## Product Change Notification / ASER-02NIOC250

CCB 6136 Final Notice: Qualification of MMT as an additional assembly site for selected MIC460xx, MIC410xx and MIC380xx device families available in 8L SOIC (3.90mm) package.

# Pre and Post Summary – Bondshell Comparison

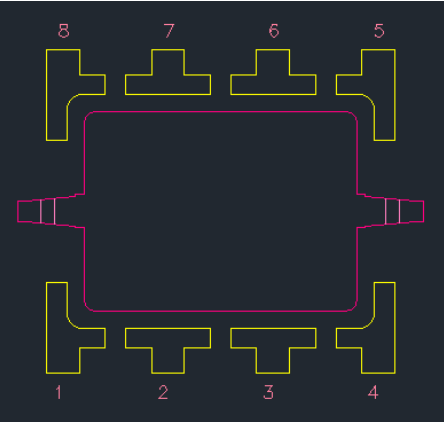
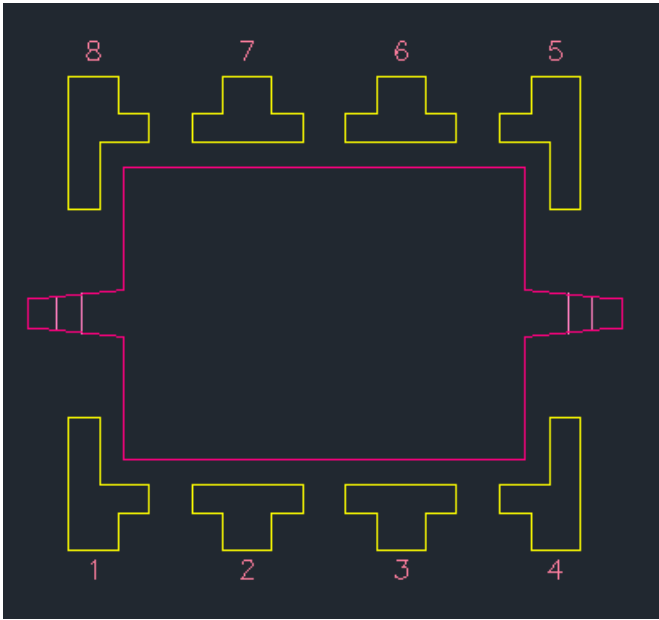
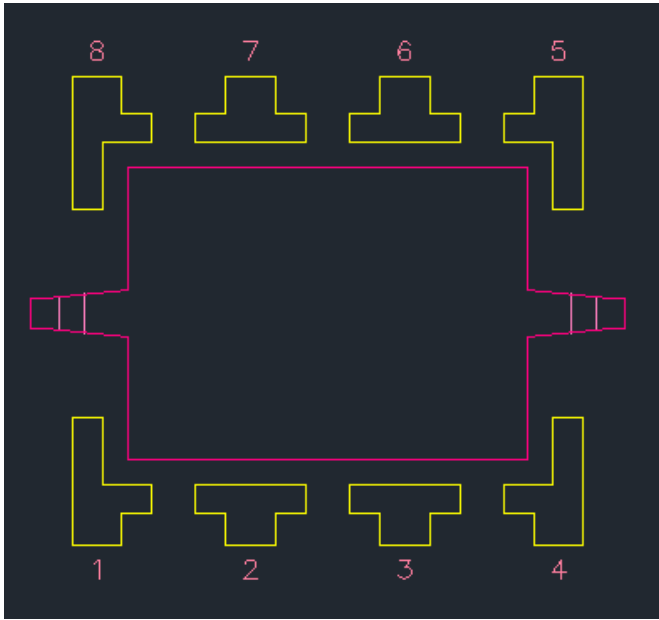
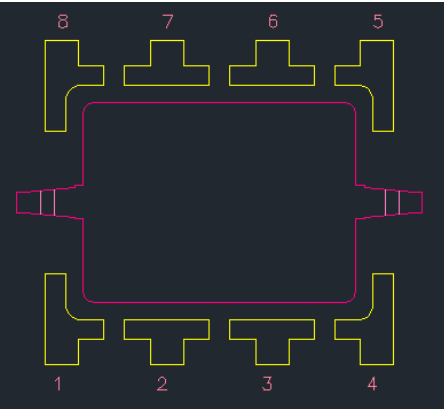
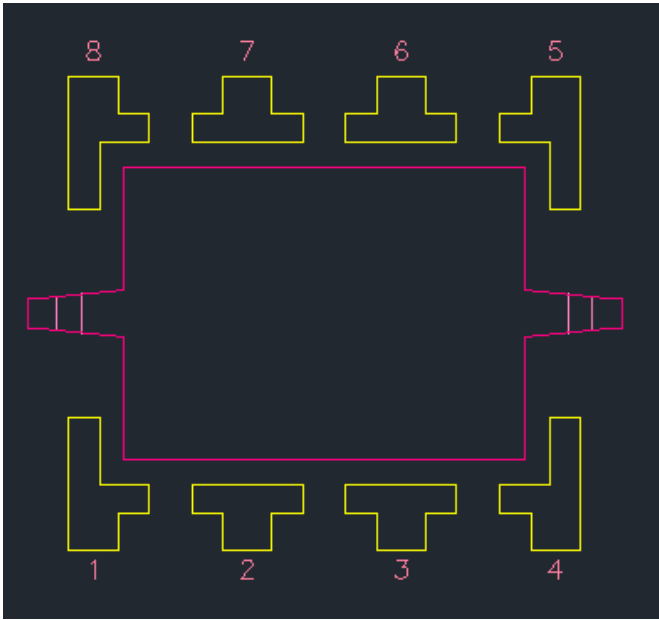
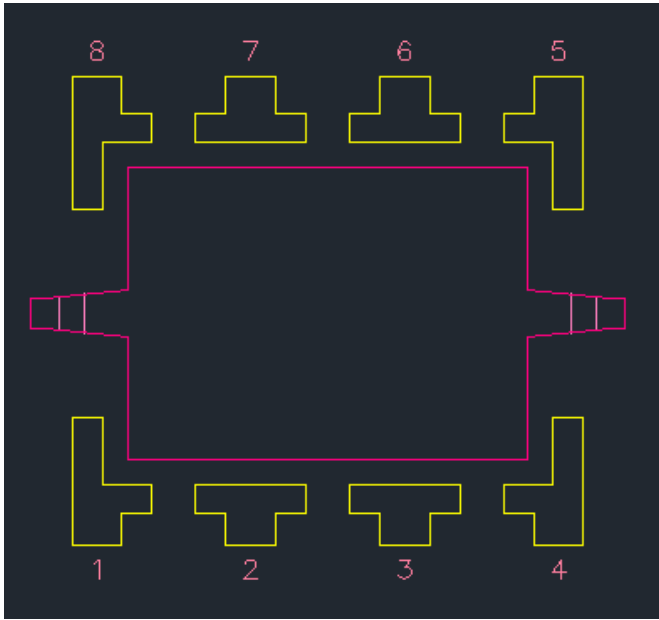
STAR		UNIS		MMT	
	Lead-Frame Material				
	A194				
	Lead-Frame Material				
	CDA194	Lead-Frame Material	A194	Lead-Frame Material	CDA194

Note: C194, A194 or CDA194 Lead-Frame material are the same, it is just a MCHP internal labelling difference.
